Subject ▶ Change on Ball Bearing

For Models ▶ PC1100 (Concrete Planer)

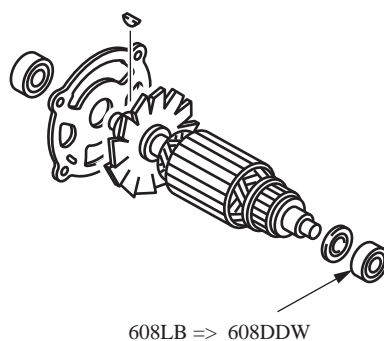
Description ▶ As illustrated below, Ball Bearing has been changed, for more dust protection.

Change on Ball Bearing : 608LB(single sealing) => 608DDW(double sealing)
Seal color : Black => Green

| Item No | Current part | | Q'ty | I/C | New part | | Q'ty | Note |
|---------|--------------------------------|--|------|-----|---------------------------------|--|------|------|
| 9 | Ball Bearing 608LB 211033-2 | | 1 | <= | Ball Bearing 608DDW 210005-4 | | 1 | |

PC1100 : From serial No.28183E(Jan. 1997 Production)
